6/20/2014	Added Dimensions
DATE	REVISION
STATE OF HAWAII DEPARTMENT OF TRANSPORTATION HIGHWAYS DIVISION	
ACCESSIBLE RAMP SECTIONS AND DETAILS	
MOTOR VEHICLE SAFETY OFFICE RENOVATION	
Project No. HWY-0-02-08	
Scale: As Noted	Date: APRIL, 2014
SHEET No. A1.5 OF 57 SHEETS

6/20/14	4 Added Mounting Heights
DATE	REVISIONS
STATE OF HAWAII DEPARTMENT OF TRANSPORTATION HIGHWAYS DIVISION <b>ELECTRICAL SYMBOLS, ENERGY CALCULATIONS</b> <b>MOTOR VEHICLE SAFETY OFFICE RENOVATION</b> Project No. HWY-0-02-08 Scale: As Noted Date: April 2014	
SHEET No. E1.0 OF 57 SHEETS

6/20/14	Revised Outlet Mounting Heights
DATE	REVISIONS
STATE OF HAWAII DEPARTMENT OF TRANSPORTATION HIGHWAYS DIVISION	
<b>BUILDING 'A' &amp; 'B' POWER PLANS - NEW WORK, SINGLE LINE DIAGRAMS - DEMOLITION &amp; NEW WORK</b>	
<b>MOTOR VEHICLE SAFETY OFFICE RENOVATION</b>	
<b>Project No. HWY-0-02-08</b>	
Scale: As Noted	Date: April 2014

**BUILDING 'A' SIGNAL  
SIGNAL PLAN - NEW WORK**  
Scale - 1/8" = 1'-0"

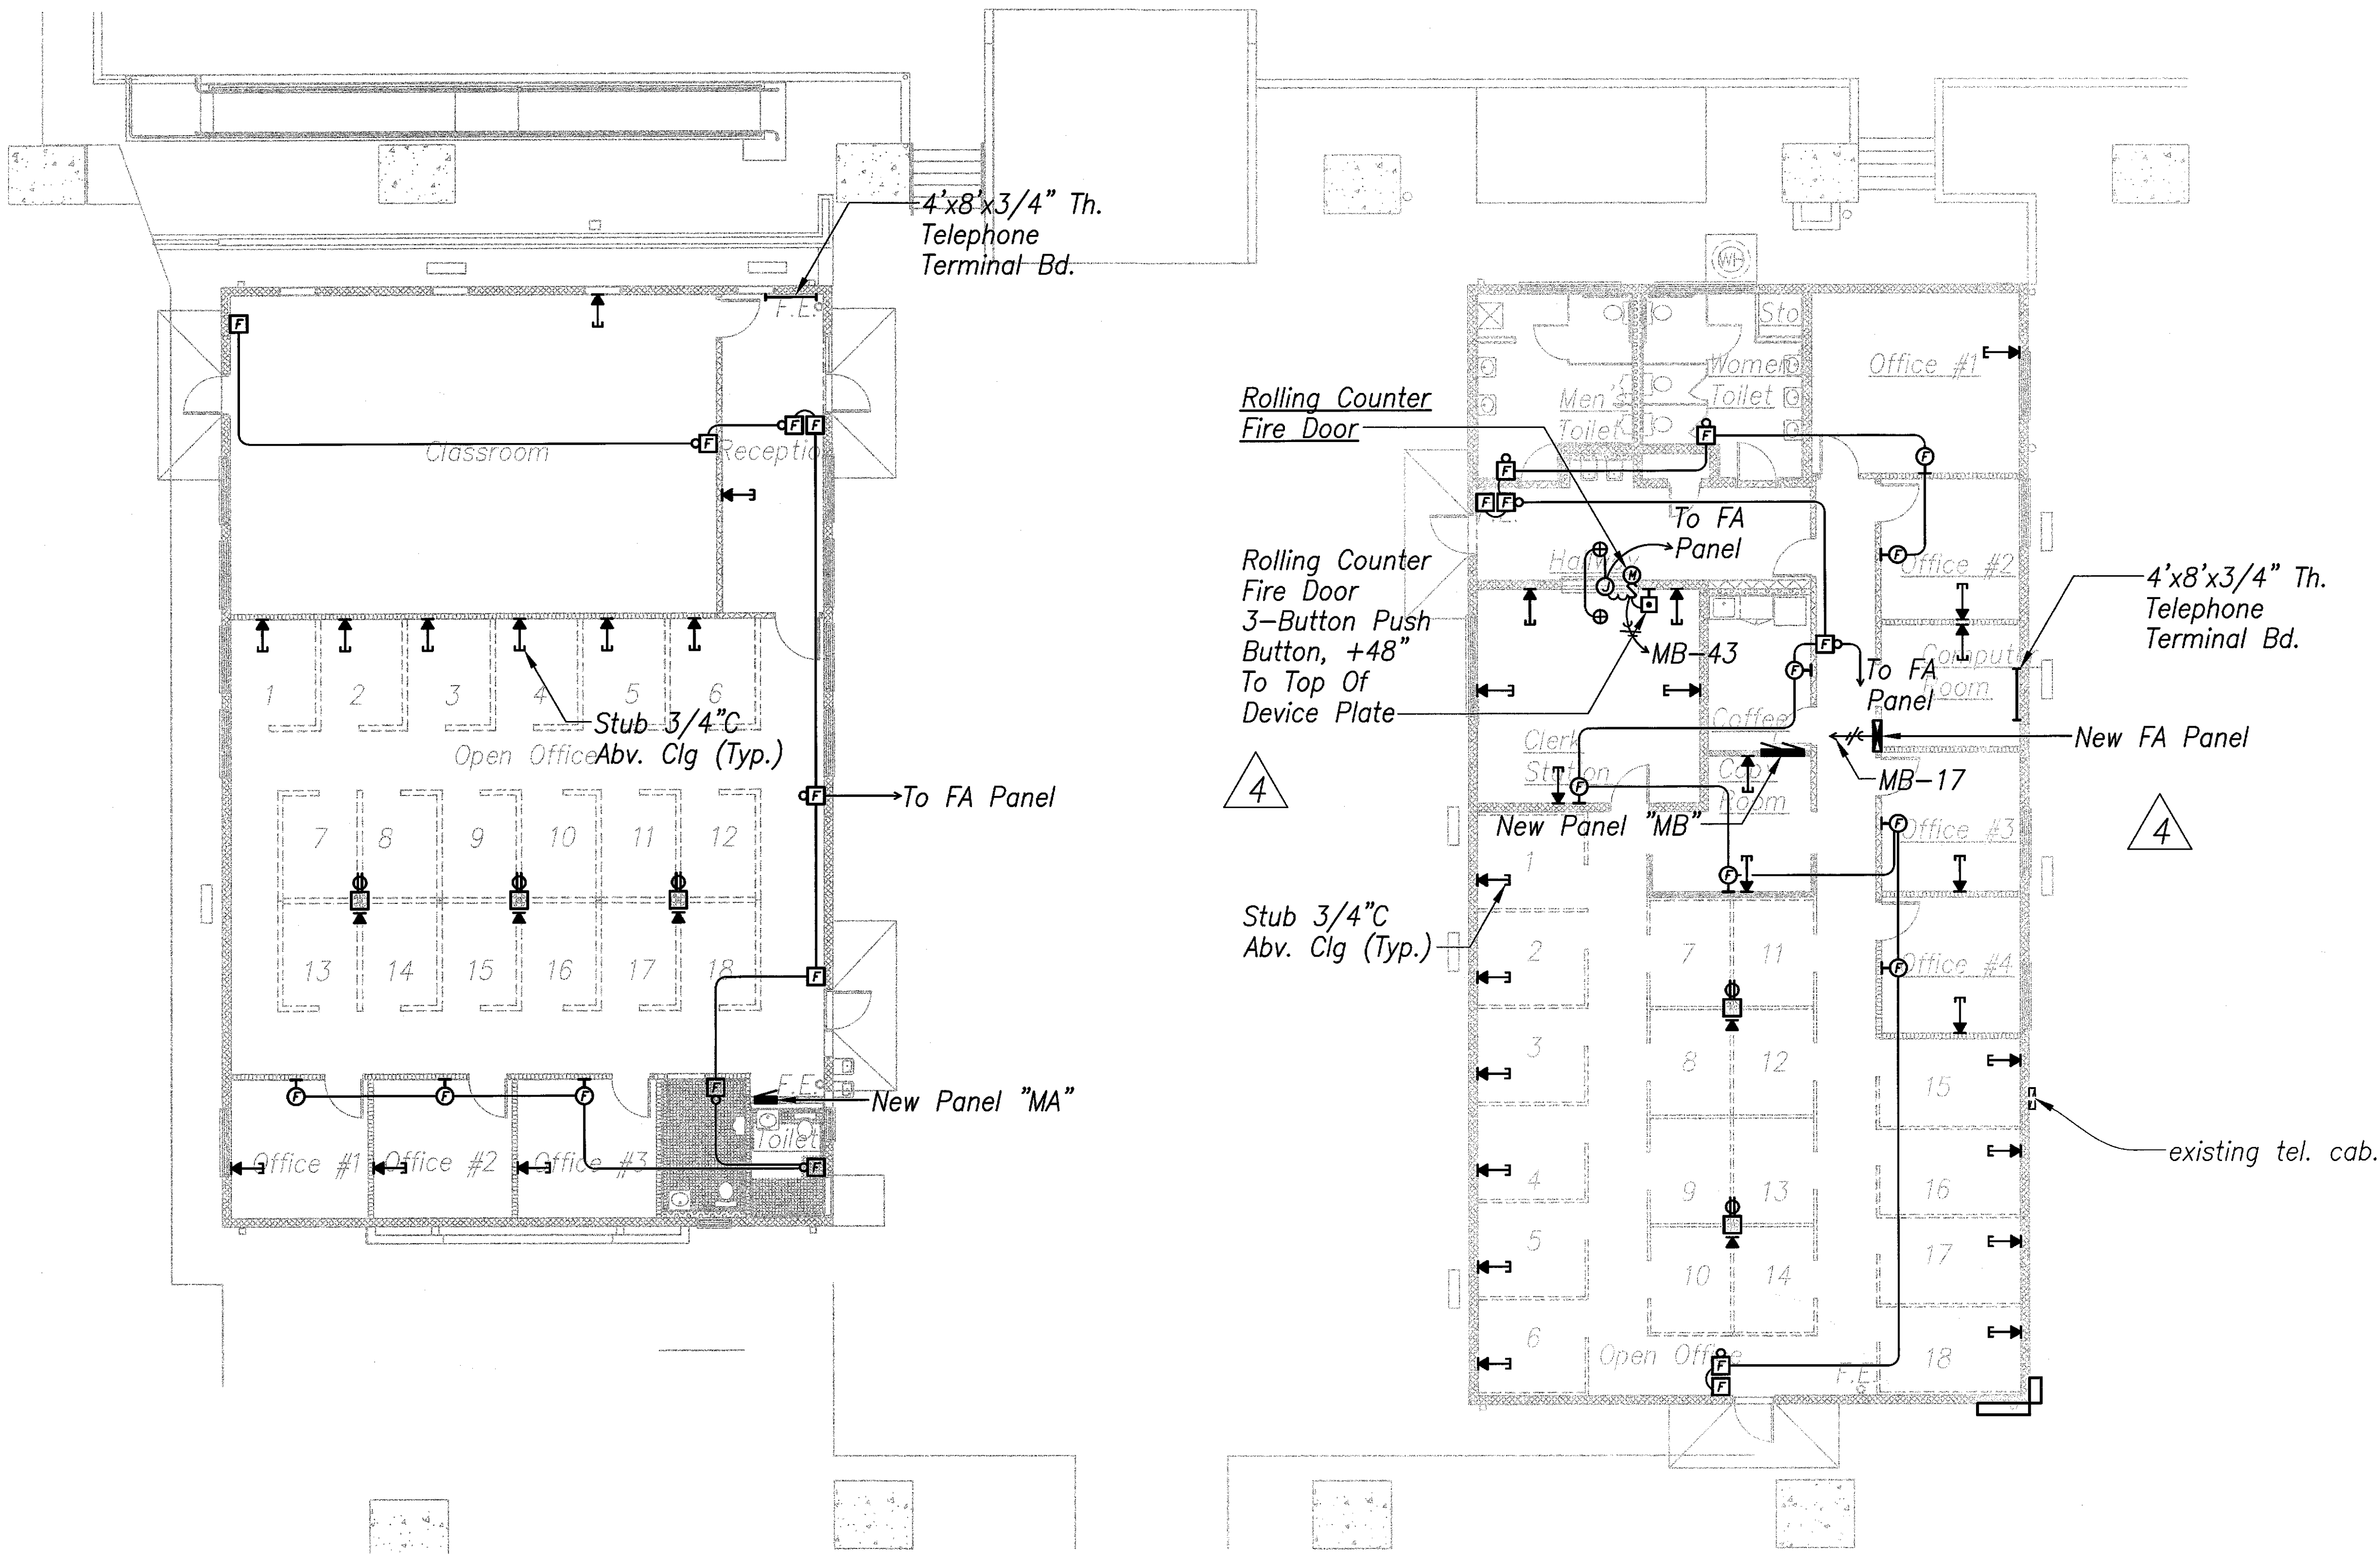
6/20/14	Indicated Push Button Mounting Height
DATE	REVISIONS
STATE OF HAWAII DEPARTMENT OF TRANSPORTATION HIGHWAYS DIVISION <b>BUILDING 'A' &amp; 'B' SIGNAL PLANS - NEW WORK</b> <b>MOTOR VEHICLE SAFETY OFFICE RENOVATION</b> Project No. HWY-0-02-08 Scale: As Noted Date: April 2014

**FIRE ALARM RISER DIAGRAM**

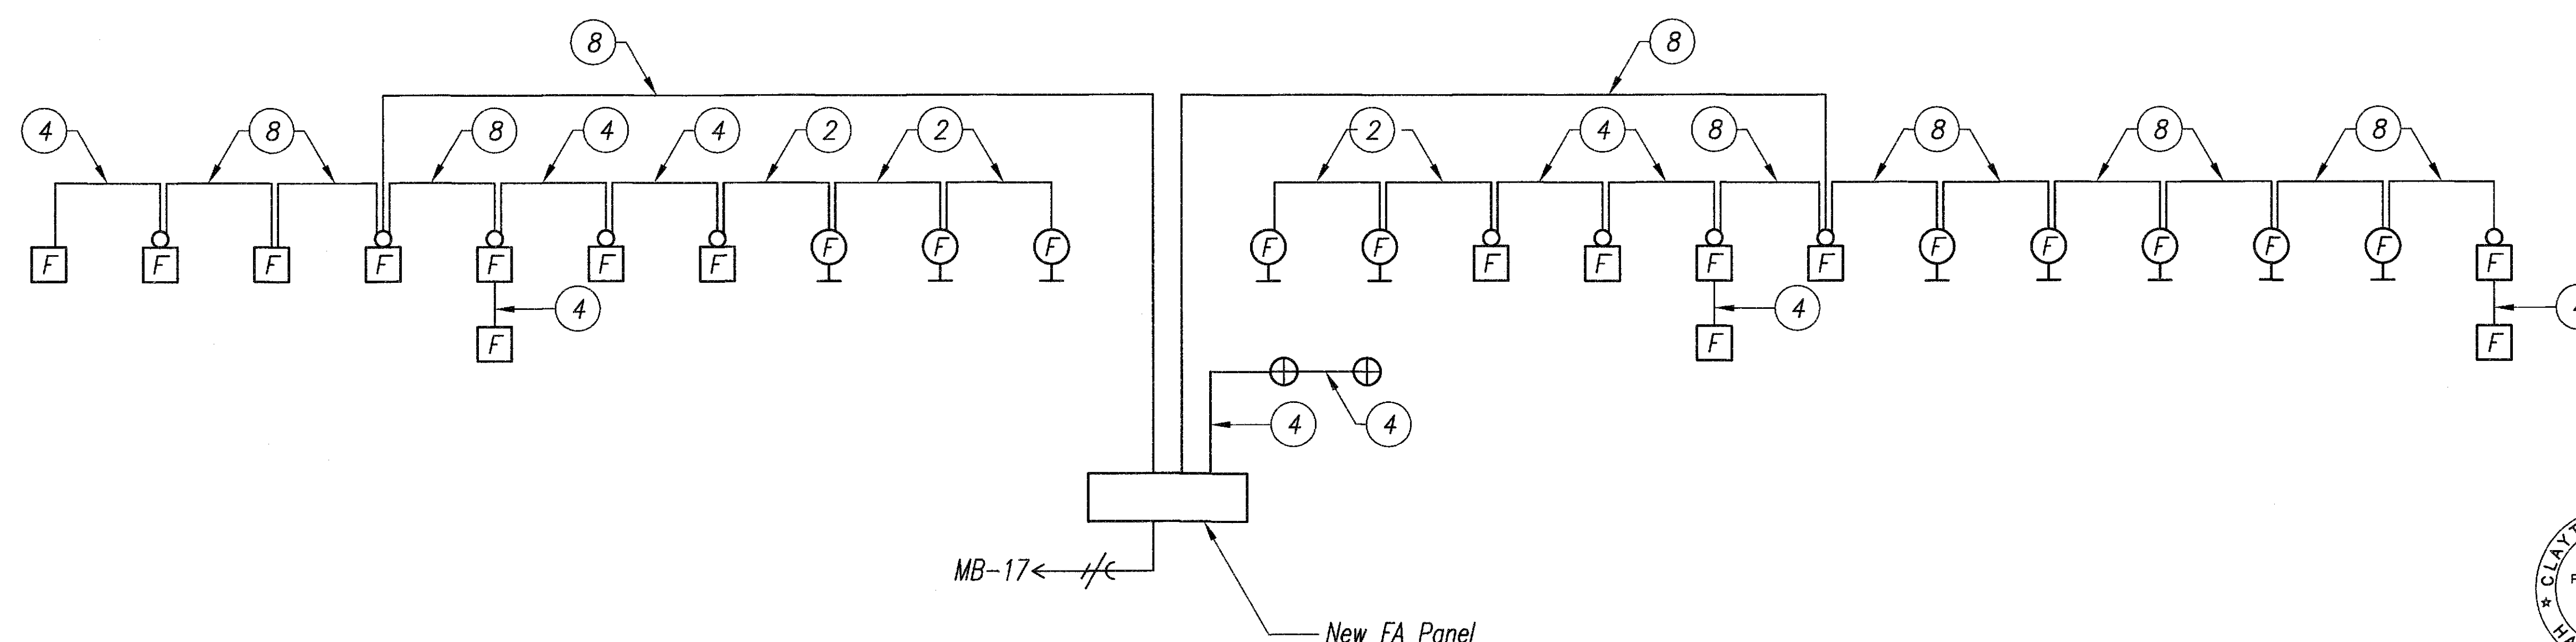
6/20/14	④ Revised Fire Alarm Note
DATE	REVISIONS
STATE OF HAWAII DEPARTMENT OF TRANSPORTATION HIGHWAYS DIVISION <b>FIRE ALARM RISER DIAGRAM</b> <b>FIRE ALARM NOTES</b>  <b>MOTOR VEHICLE SAFETY OFFICE</b> <b>RENOVATION</b> Project No. HWY-0-02-08 Scale: As Noted Date: April 2014	
SHEET No. E3.2 OF 57 SHEETS

- Detection, Alarm, And Communication Systems
- 13.7.1.1 Where Building Fire Alarm Systems Or Automatic Fire Detectors Are Required By Other Sections Of This Code, They Shall Be Provided And Installed In Accordance With NFPA 70, NFPA 72 (1999 Edition), National Fire Alarm Code, And Section 13.7. 2006 NFPA 1. ④
